Modifications of CMC Unit Configuration

SHINKO ELECTRIC CO., LTD.

Research & Development Laboratory

Fig. 2 Modified base CMC configuration

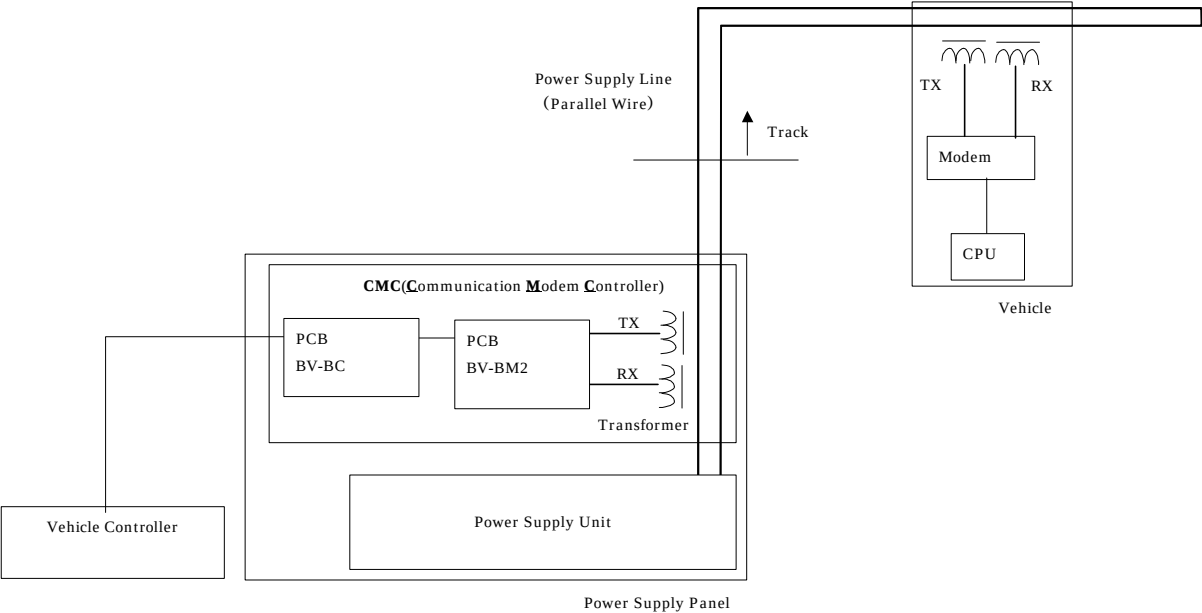
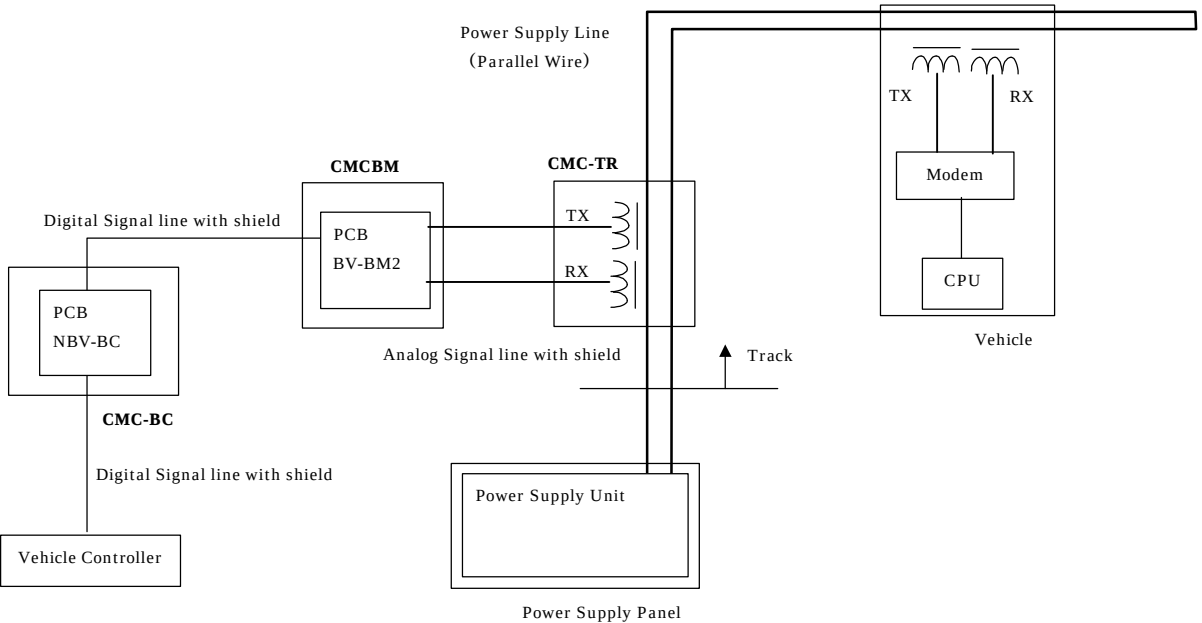
- ① The CMC unit is located outside the Power Supply Panel.
- ② The CMC unit is divided into the following three units.
 - CMC-BC (Interface for signals from Vehicle Controller. Multiplexer between CMC and BM)

- CMC-BM (Signal modulation/demodulation between Vehicle Controller and several vehicles)
 - CMC-TR (Transformers overlaying signals onto the power or signal line and picking up the signals)

- ③ The print circuit board BV-BC is replaced with NBV-BC. However, these two have the same digital circuits. Only the number of output ports has been changed as follows.

- BV-BC (current): 6 output ports
 - NBV-BC (new): 8 output ports
- ④ The unit now allows the user to transmit communication signals through a separate signal line instead of the current method, i.e. overlaying signals onto the non-conductive power line.

- ⑤ Figure 2 shows the basic CMC configuration.
- ⑥ Figure 3 shows one example of CMC configuration. In this configuration, one NBV-BC board handles the outputs to several BV-BM2 boards.

Fig. 4 Modified CMC configuration Example 2

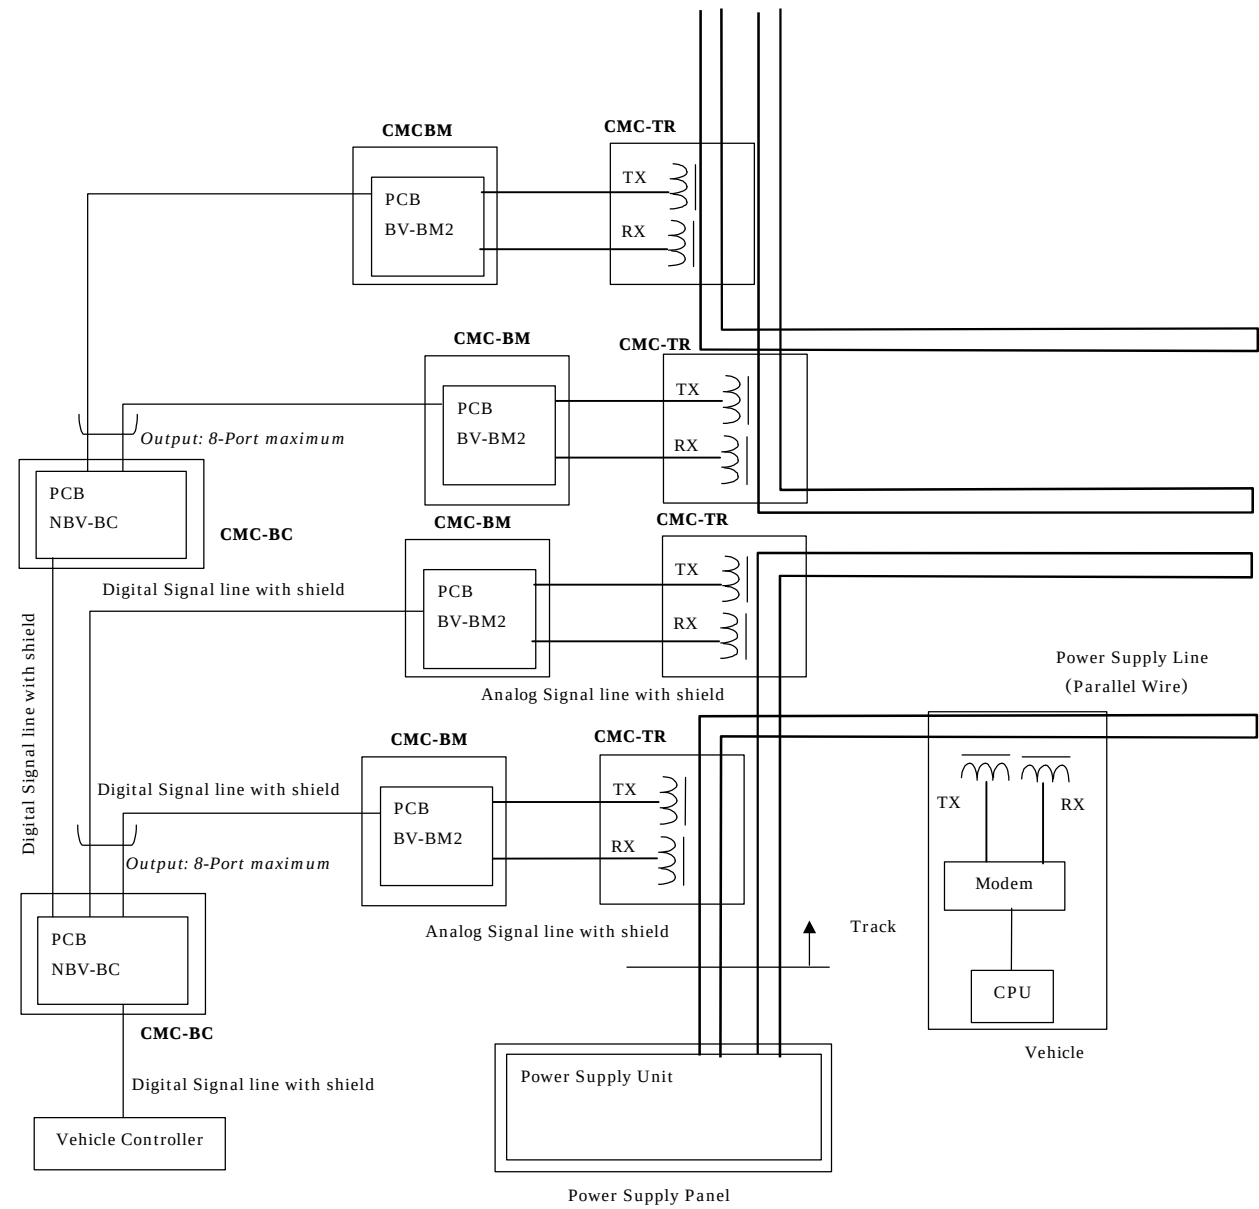
- ⑦ Figure 4 shows another example of CMC configuration. Also in this configuration, one NBV-BC board handles the outputs to several BV-BM2 boards. The NBV-BC boards can serve either as the master or as a slave. The number of NBV-BC boards is determined by the system scale.
